Service Technical Information

MODEL NO. MD Mechanism 3ZG-5
SUBJECT Warnings when replacing SHAFT, PU GUIDE A and HLDR, PU GUIDE A

REF.No. :G - A0 - 010 - E0

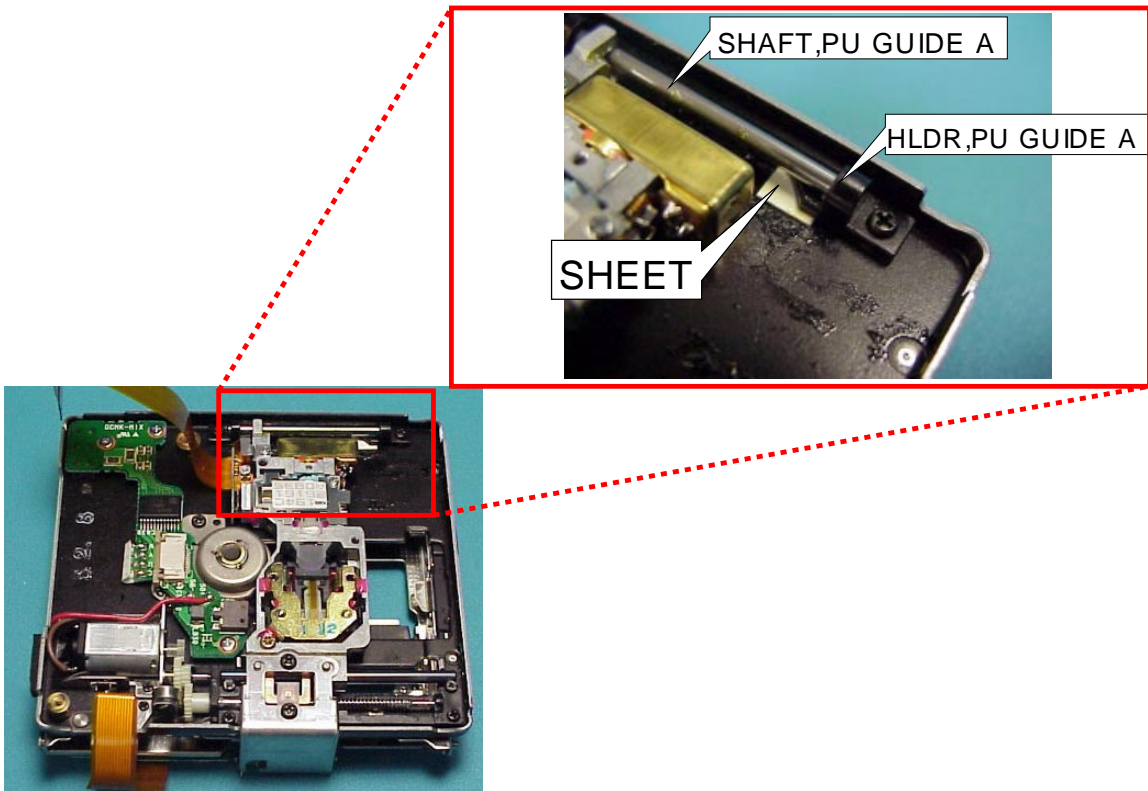
SHAFT, PU GUIDE A, and HLDR, PU GUIDE A are being modified.

To maintain compatibility, please confirm whether or not the sheet in the following diagram is present.

When the sheet is present:

When the sheet is not present:

Remove the sheet and replace at the same time SHAFT, PU GUIDE A, and HLDR, PU GUIDE A with the parts listed in the part codes below.

SHAFT, PU GUIDE A, and HLDR, PU GUIDE A, respectively, can be replaced individually. However, upon replacement, use the part numbers listed in the part codes below.
